Access Compliance Report Public Rights-of-Way (Curb Ramps)

Main Street: WINDSOR_LN Cross Street: ENRAMADA_DR Location: SW

ADA ID: RPAT21101111117 Ramp Type: Type 6 - Directional 1 Initial Pass/Fail: Fail Overall Compliance: No Severity Score: 4

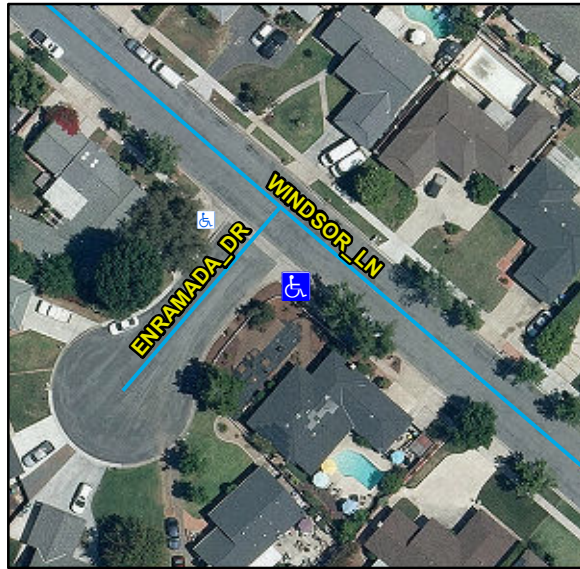
R304.5.1, STD 1115

Remove & Replace Curb Ramp With Two New Directional Ramps or Equivalent.
